SUBJECT: Post-Construction Report for the Wetland Area at Dunbarton Bay in Support of Steel Creek Integrator Operable Unit (U) (SRNS-RP-2020-00003, Revision 1, October 2020) (Redline Pages and Clean Copy) and Savannah River Site's Responses to the Regulatory Comments on the Revision 0 Document SEMS, Number: 71

Post-Construction Report for the Wetland Area at Dunbarton Bay in Support of Steel Creek Integrator Operable Unit (U)

SRNS-RP-2020-00003

Responses to the
South Carolina Department of Health and Environmental Control Comments on:
Post-Construction Report for the Wetland Area at Dunbarton Bay
in Support of Steel Creek Integrator Operable Unit (U),
SEMS Number: 71 (SRNS-RP-2020-00003, Revision 0, June 2020) received June 4, 2020.

Figure 7. Additional Ash Outside the Limits of Ash Discovered During Phase I Activities in the NARASARA Phase II Excavation of Ash in Zone 1

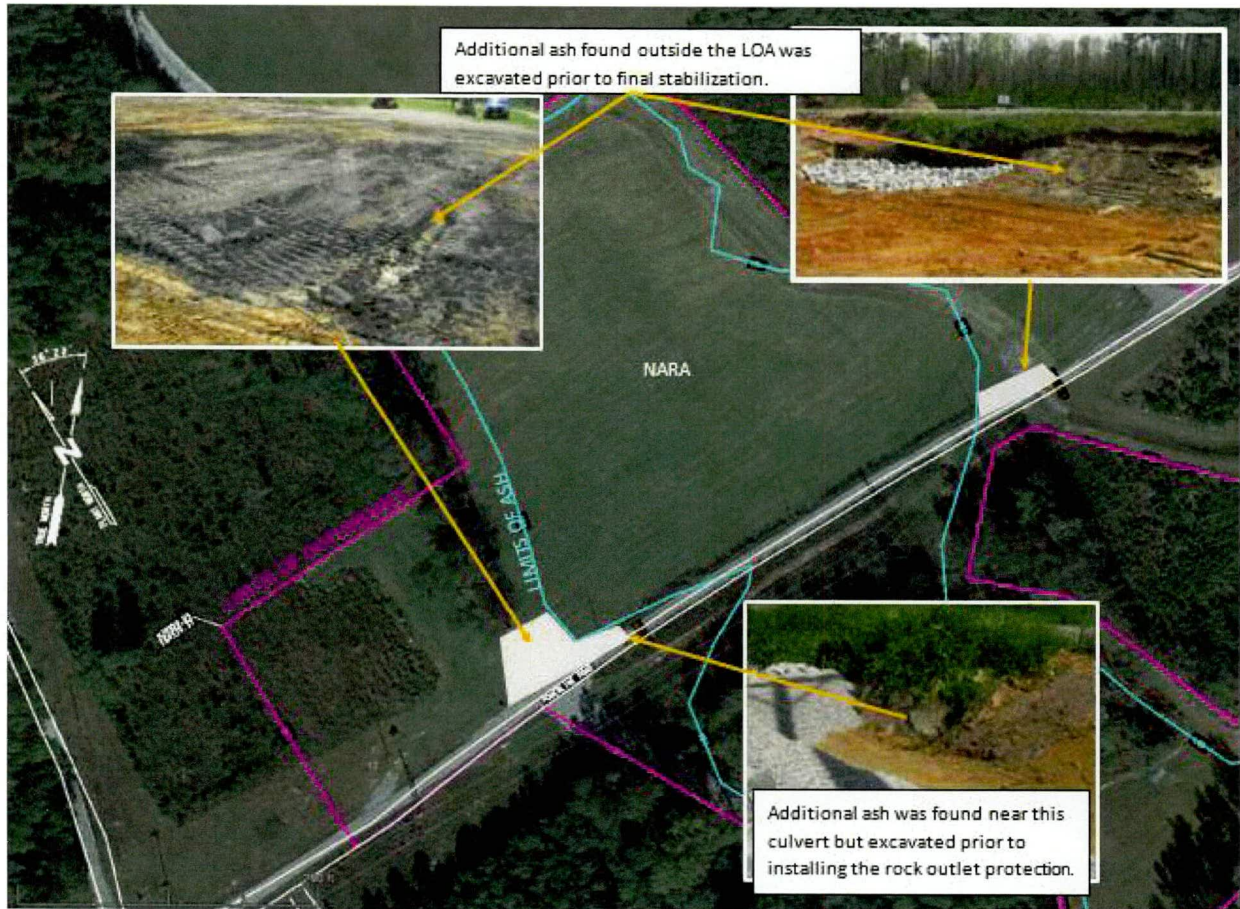
1. Table 4, Summary of Design Changes, page 40. Items 4 and 6 of this table indicate that additional ash was found outside of the original boundary for the limits of ash in two separate areas of the North Ash Remediation Area (NARA) - one location at the outfall structure of a sediment trap on the eastern side and the other at a designed diversion berm location on the southwestern corner. There appears to be no discussion of this additional ash in Sections 2.3.2.2 or 2.3.3.2 or a general figure showing these locations, as was done for the additional ash discovered outside of the original boundary at the South Ash Remediation Area (SARA). Please include a brief discussion and a figure showing the extent of additional ash at these two locations.

The sediment trap construction included the excavation of a low-lying area to allow runoff from within the contaminated area to pond, and a rock outlet structure to trap sediment and prevent release of sediment outside of the NARA. During construction of the sediment trap, ash was found outside of the limits of ash boundary as identified on the design drawings. This additional ash included a narrow band which was parallel to the road and upgradient of the triple culverts (see Figure 7). A portion of this additional ash, where the rock outlet structure was installed, was excavated during Phase I activities. The remaining share was excavated during Phase II activities.

Two diversion berms were installed in the NARA for sediment and erosion control. These diversion berms ran north-south along the east and west sides of the contaminated ash and prevented sheet flow from the adjacent areas from entering the contaminated area. Additional ash was found outside of the limits of ash during the installation of the diversion berm in the southwestern corner of the NARA (Figure 7). Ash near the culvert was excavated prior to installing the rock outlet protection. Ash to the west of the berm was excavated during Phase II activities prior to final stabilization.
